L-2018-049

Florida Power & Light Company  
St. Lucie Units 1 and 2, Docket Nos. 50-335, 50-389  
Turkey Point Units 3 and 4, Docket Nos. 50-250, 50-251

NextEra Energy Seabrook, LLC  
Seabrook Station, Docket No. 50-443

Subject: Application to Add Limiting Condition for Operation (LCO) 3.0.6 to the Technical Specifications

Figure B 3.0-1  
Configuration of Trains and Systems

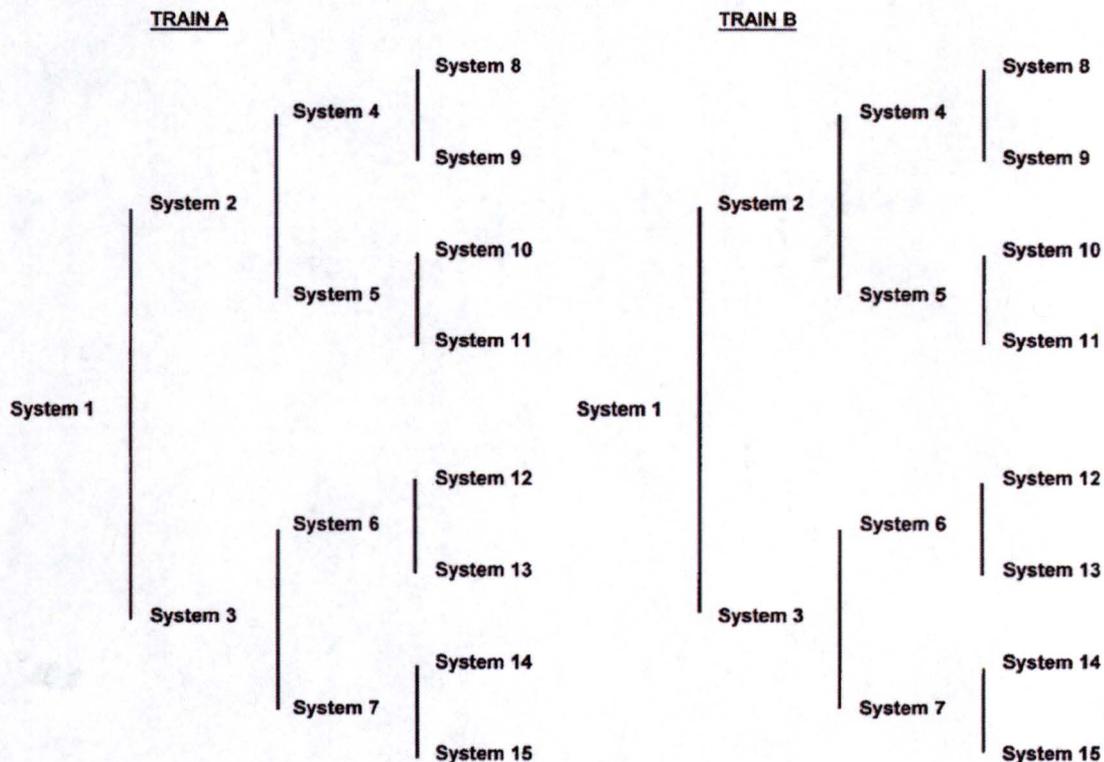
The following examples use Figure B 3.0-1 to illustrate loss of safety function conditions that may result when a TS support system is inoperable. In this figure, the fifteen systems that comprise Train A are independent and redundant to the fifteen systems that comprise Train B. To correctly use the figure to illustrate the SFDP provisions for a cross train check, the figure establishes a relationship between support and supported systems as follows: the figure shows System 1 as a support system for System 2 and System 3; System 2 as a support system for System 4 and System 5; and System 4 as a support system for System 8 and System 9. Specifically, a loss of safety function may exist when a support system is inoperable and:

If System 2 of Train A is inoperable, and System 1 of Train B is inoperable, a loss of safety function exists in Systems 2, 4, 5, 8, 9, 10 and 11.

If an evaluation determines that a loss of safety function exists, the appropriate ACTIONS of the LCO in which the loss of safety function exists are required to be entered.

Figure B 3.0-1  
Configuration of Trains and Systems

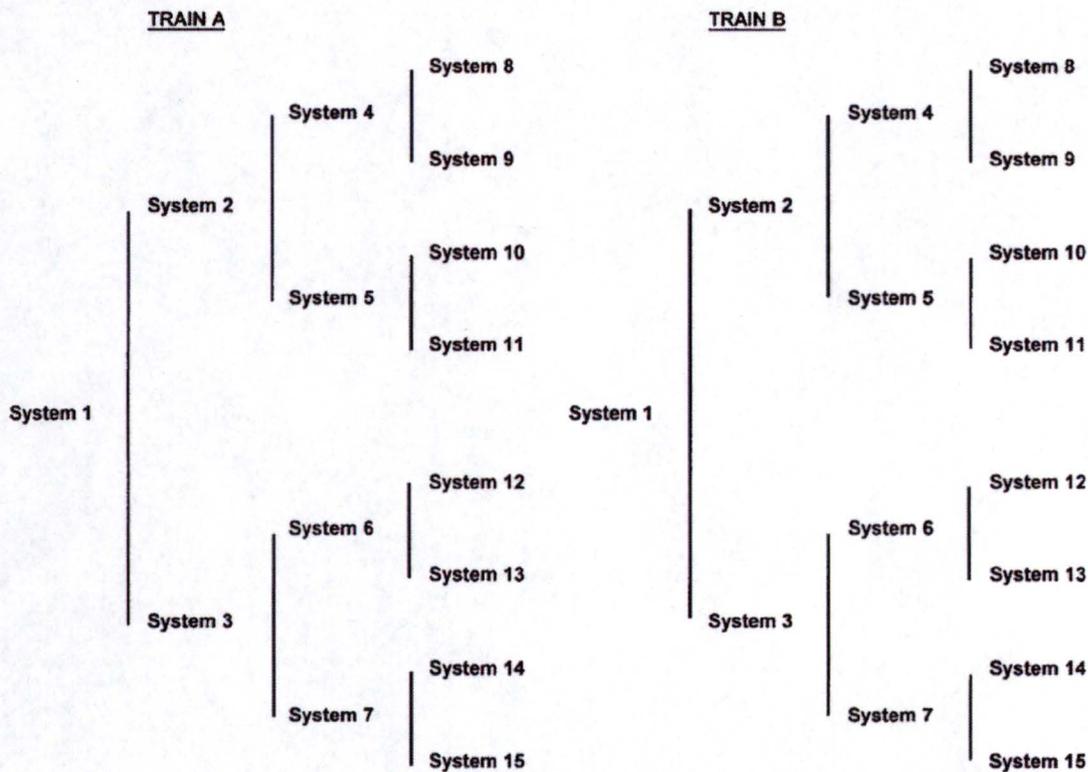
The following examples use Figure B 3.0-1 to illustrate loss of safety function conditions that may result when a TS support system is inoperable. In this figure, the fifteen systems that comprise Train A are independent and redundant to the fifteen systems that comprise Train B. To correctly use the figure to illustrate the SFDP provisions for a cross train check, the figure establishes a relationship between support and supported systems as follows: the figure shows System 1 as a support system for System 2 and System 3; System 2 as a support system for System 4 and System 5; and System 4 as a support system for System 8 and System 9. Specifically, a loss of safety function may exist when a support system is inoperable and:

If System 2 of Train A is inoperable, and System 1 of Train B is inoperable, a loss of safety function exists in Systems 2, 4, 5, 8, 9, 10 and 11.

If an evaluation determines that a loss of safety function exists, the appropriate ACTIONS of the LCO in which the loss of safety function exists are required to be entered.

Figure B 3.0-1  
Configuration of Trains and Systems

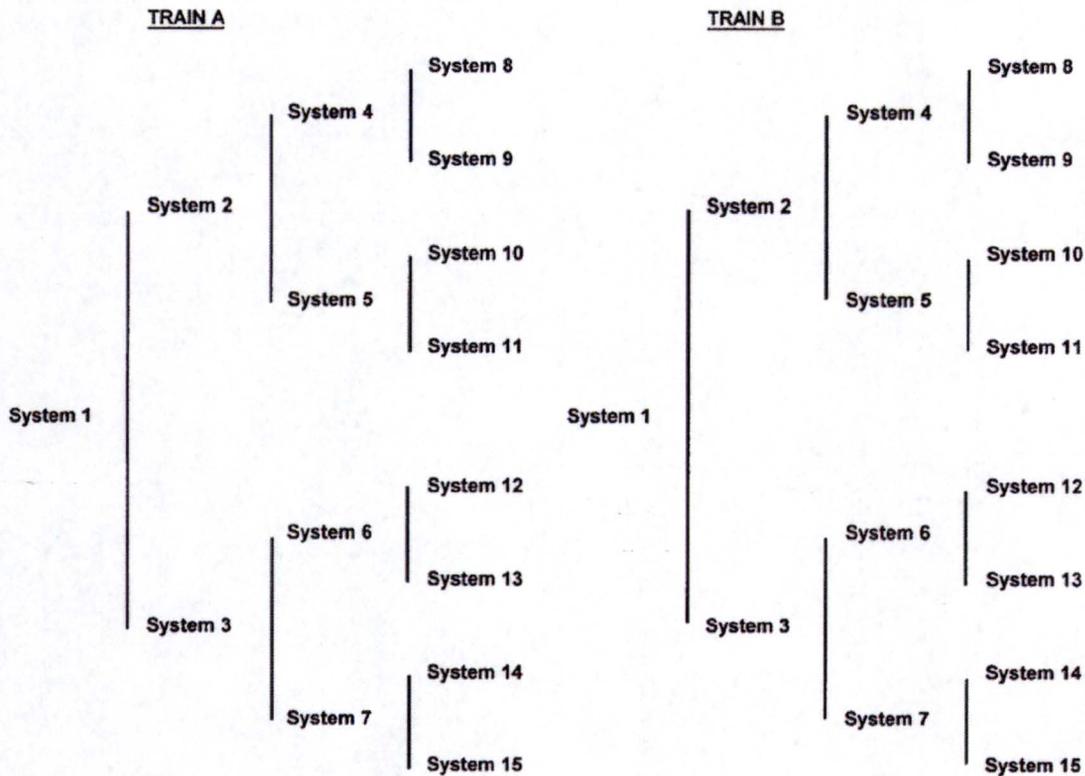
The following examples use Figure B 3.0-1 to illustrate loss of safety function conditions that may result when a TS support system is inoperable. In this figure, the fifteen systems that comprise Train A are independent and redundant to the fifteen systems that comprise Train B. To correctly use the figure to illustrate the SFDP provisions for a cross train check, the figure establishes a relationship between support and supported systems as follows: the figure shows System 1 as a support system for System 2 and System 3; System 2 as a support system for System 4 and System 5; and System 4 as a support system for System 8 and System 9. Specifically, a loss of safety function may exist when a support system is inoperable and:

If System 2 of Train A is inoperable, and System 1 of Train B is inoperable, a loss of safety function exists in Systems 2, 4, 5, 8, 9, 10 and 11.

If an evaluation determines that a loss of safety function exists, the appropriate ACTIONS of the LCO in which the loss of safety function exists are required to be entered.

Figure B 3.0-1  
Configuration of Trains and Systems

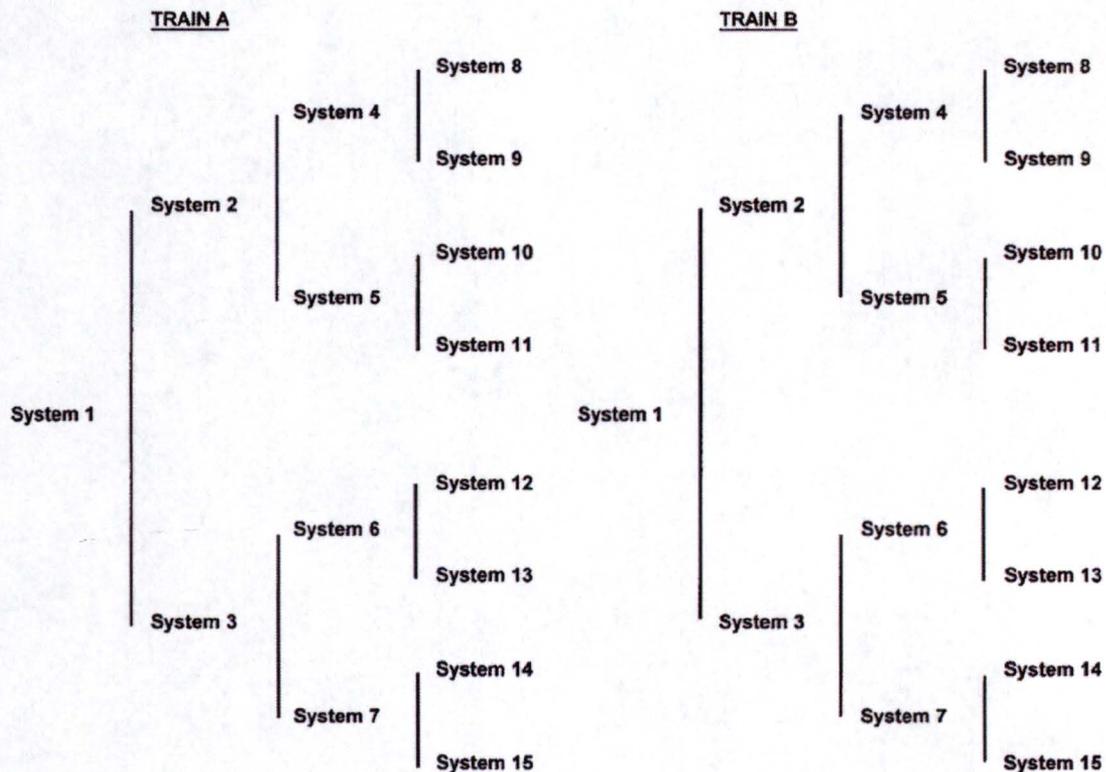
The following examples use Figure B 3.0-1 to illustrate loss of safety function conditions that may result when a TS support system is inoperable. In this figure, the fifteen systems that comprise Train A are independent and redundant to the fifteen systems that comprise Train B. To correctly use the figure to illustrate the SFDP provisions for a cross train check, the figure establishes a relationship between support and supported systems as follows: the figure shows System 1 as a support system for System 2 and System 3; System 2 as a support system for System 4 and System 5; and System 4 as a support system for System 8 and System 9. Specifically, a loss of safety function may exist when a support system is inoperable and:

If System 2 of Train A is inoperable, and System 1 of Train B is inoperable, a loss of safety function exists in Systems 2, 4, 5, 8, 9, 10 and 11.

If an evaluation determines that a loss of safety function exists, the appropriate ACTIONS of the LCO in which the loss of safety function exists are required to be entered.
